**Chemung County Stormwater  
Construction Inspection  
Erosion and Sediment Control**

Project Name: <u>Parmenter Tire</u>	Date: <u>11/12/2013</u>
Location: <u>Holding Point Horseheads (v)</u>	Permit #: <u>NYR10X325</u>
Weather Conditions: <u>clear - cold blustery</u>	Entry Time:
On-Site Representative Present: <u>Bob Young - Village</u>	Exit Time:
Sketch of Project site - Include Disturbed Areas: <u>of horseheads</u>

**PROJECT:** Parmenter Tire  
Village of Horseheads  
November 12, 2013  
Municipal Construction

**PARMENTER TIRE STORAGE AREA**  
VILLAGE OF HORSEHEADS, CHEMUNG COUNTY, N.Y.

**GRADING & UTILITY PLAN**  
**C3**

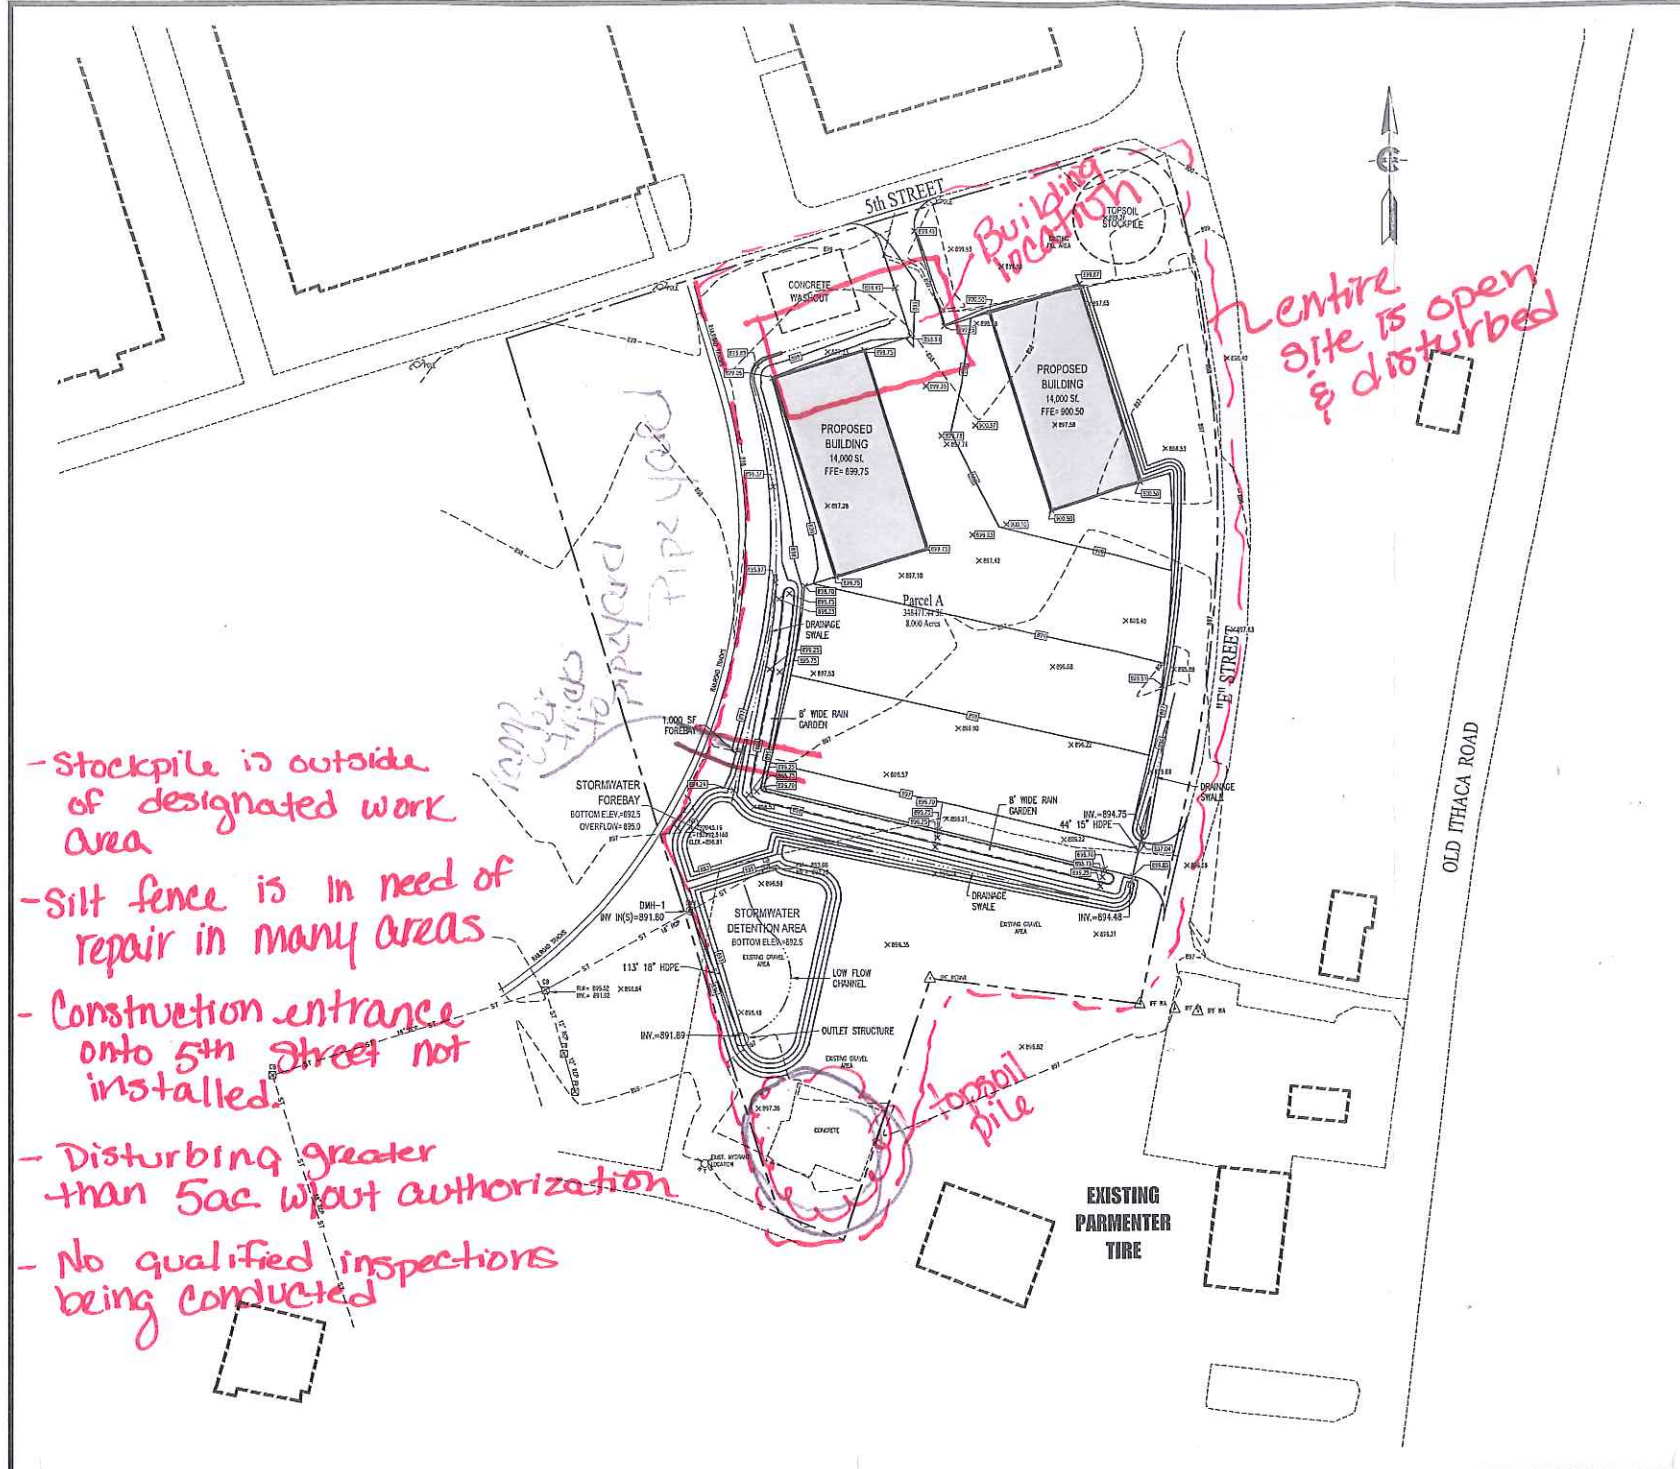
Building location-Building is not sited according to the plan and not set back 100' from 5<sup>th</sup> street as plan shows.

Entire site is open and disturbed without 5 acre written authorization.

Stormwater pond has been graded in.

Silt fence is down or off its posts in many areas around the site.

footers filled in

- Stockpile is outside of designated work area
- Silt fence is in need of repair in many areas
- Construction entrance onto 5th Street not installed
- Disturbing greater than 5ac w/out authorization
- No qualified inspections being conducted
